Addendum Number: 01

Addendum Issue Date: April 17, 2025

Project Name: Robinson Washington Elementary
Renovation & Addition

Project Number: 02401781.001

E3.3

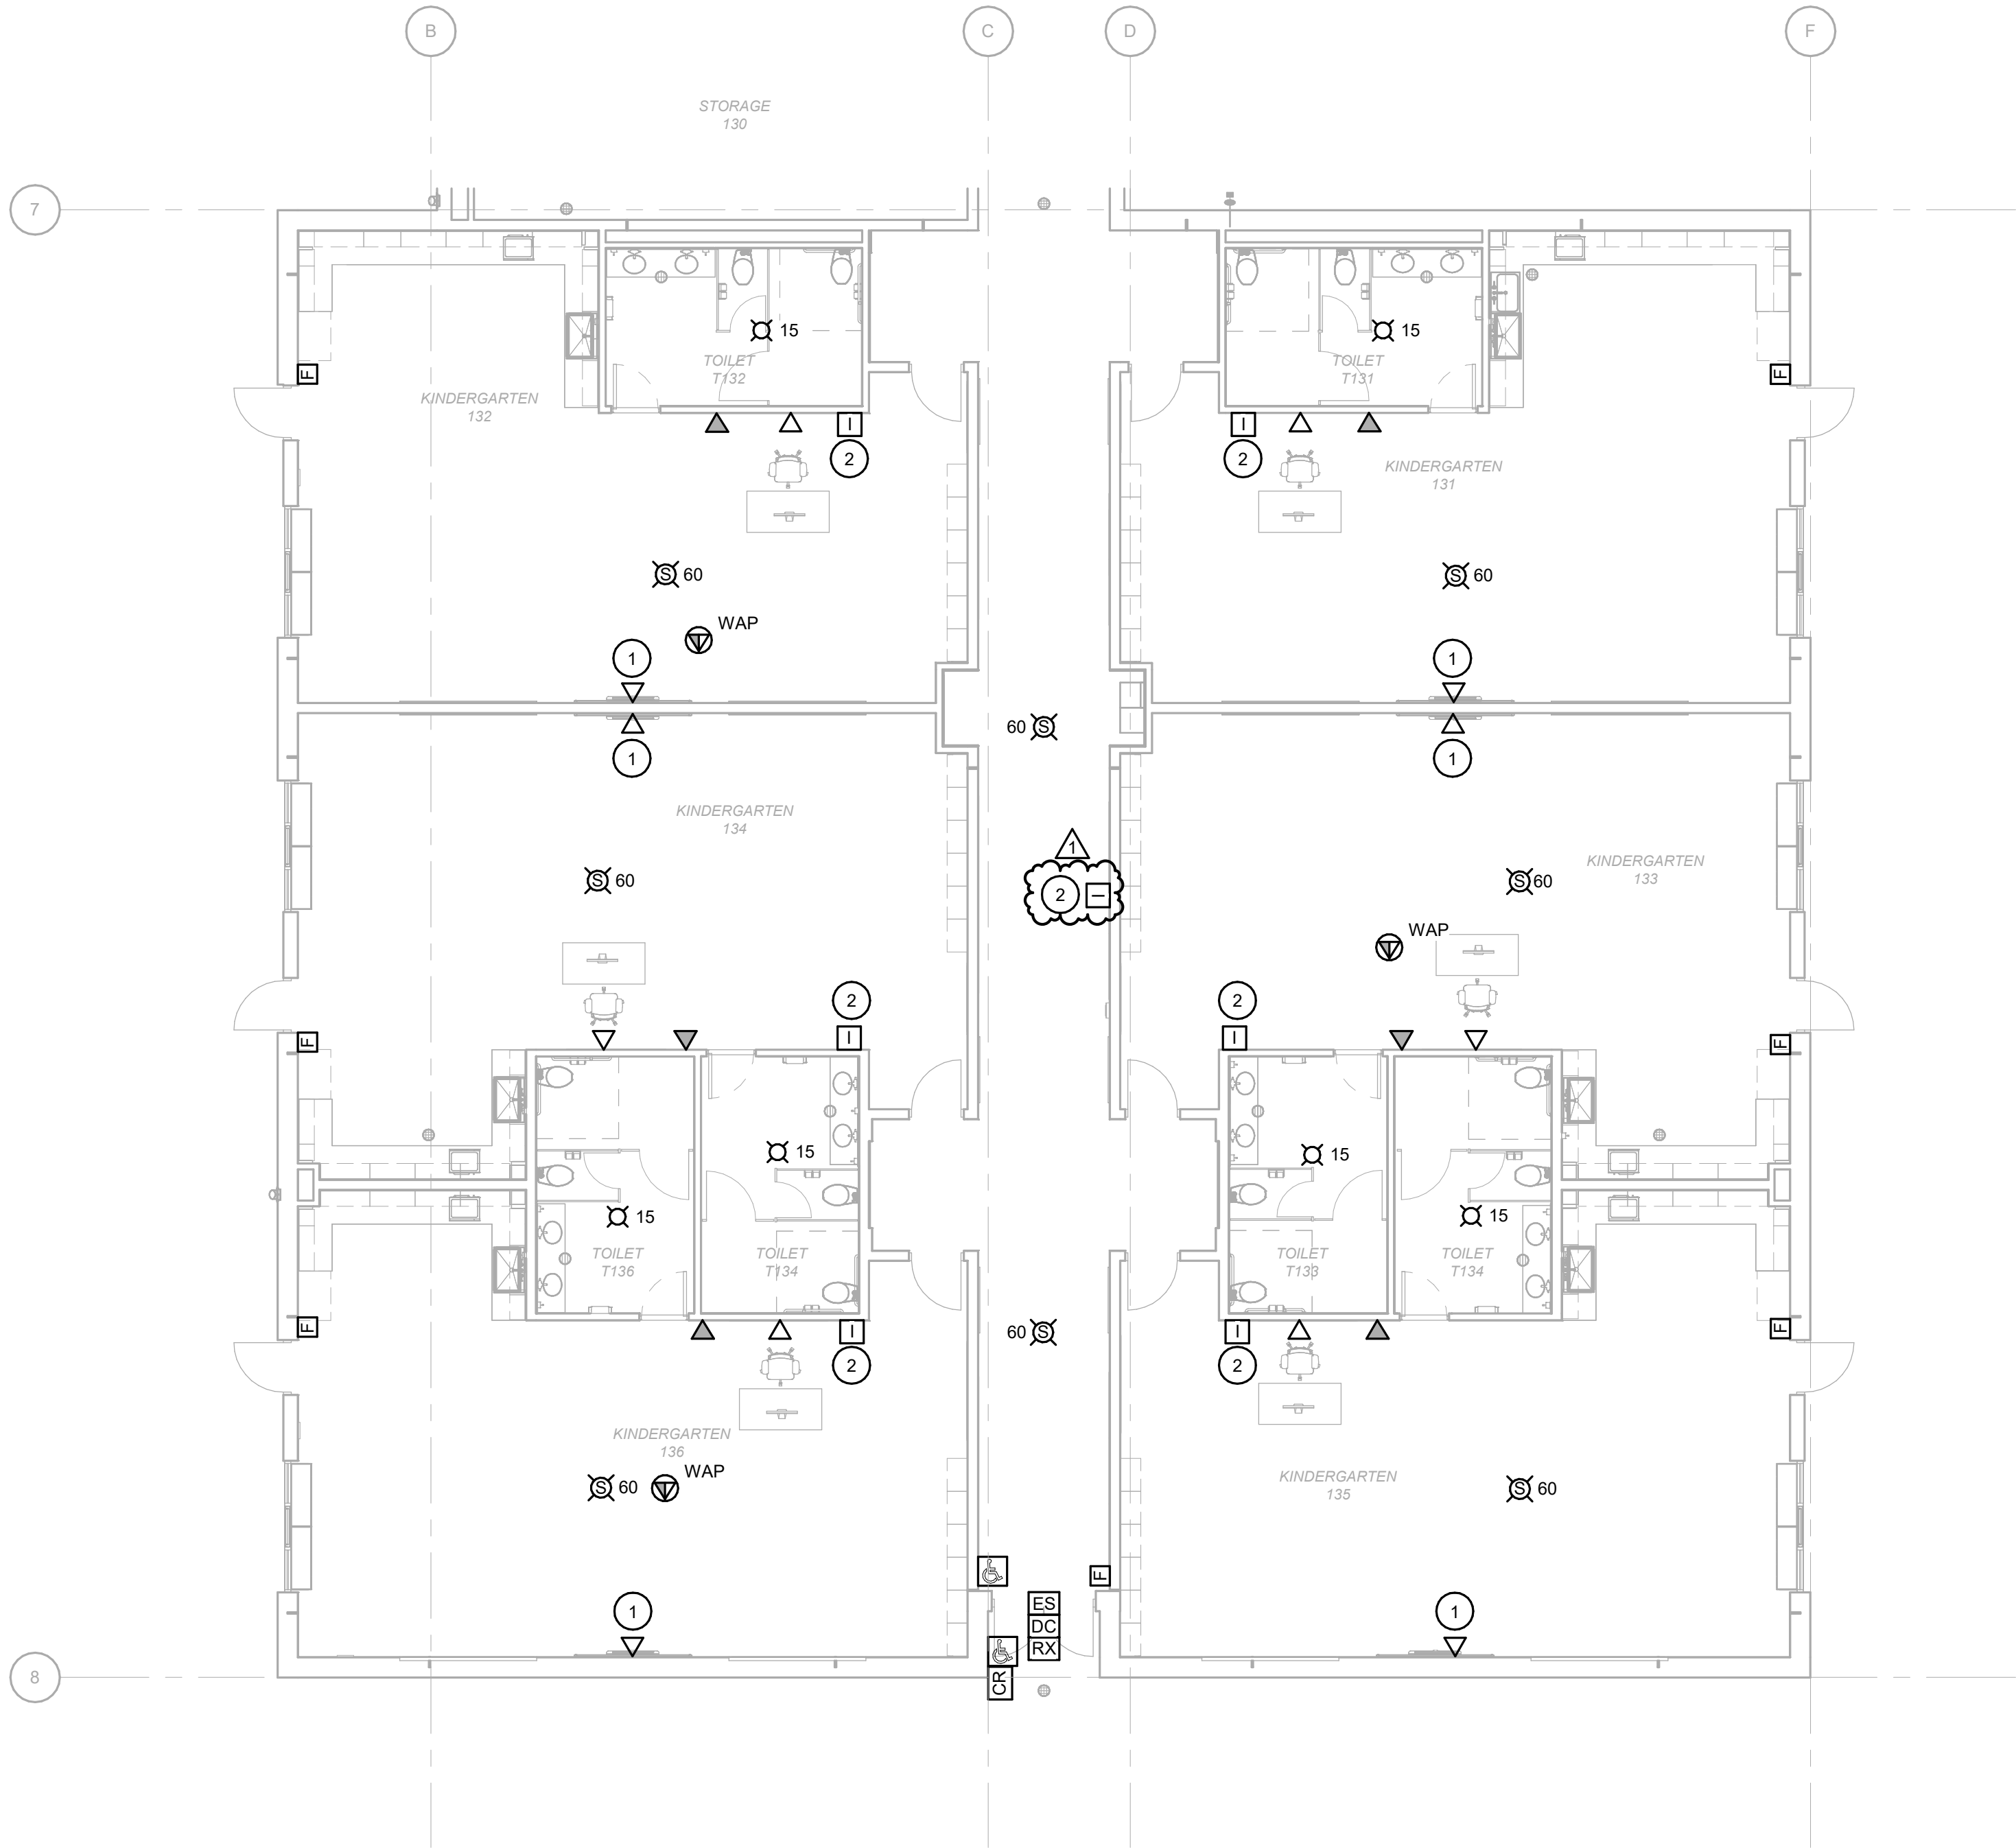
46. E3.3 – FIRST FLOOR SYSTEMS PLAN – AREA C
- a. ADD intercom location. See attached sheet.
47. E5.1 – SCHEDULES
- a. REVISE information for luminaires G1, G2, L3A, L3B, L3G, L3O, L3R, and L3Y in luminaire schedule. See attached sheet.
